MEMORANDUM

SUBJ: DEIR for GPU5 pertaining to Carmel Valley Traffic Issues

APPENDIX 3: EXTENT OF EXPOSURE TO GREATER TRAFFIC BY LOWERING THE LOS STANDARD

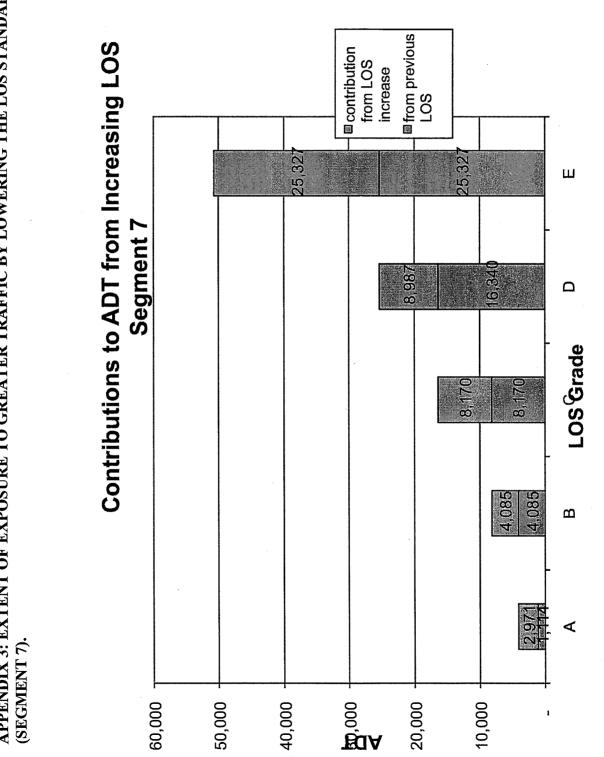
COUNTY in the Carmel Valley Master Plan. It is a goal to be achieved over the life of the plan." [emphasis in original]. GPU5 also establishes the LOS standard at "C" (CV-2.12). Yet, the DEIR establishes LOS lower than C as a standard. Why? The DEIR is also internally inconsistent in identifying LOS by segment, and is inconsistent with other county studies of LOS in Carmel Valley, including the CVTIP. Please see Appendix 2 as an example of this inconsistency. Lowering the LOS standard has the added disadvantage of allowing even greater levels of traffic in the future. For example, if an ADT standard is changed from LOS C to LOS D, the change creates an opening for a 50% increase in traffic; from D to E creates an opening for a 100% increase; from C to E creates a 300% opening. Please see Appendix 3 for an example on Segment 7 of increased traffic potential due to declining LOS standards.
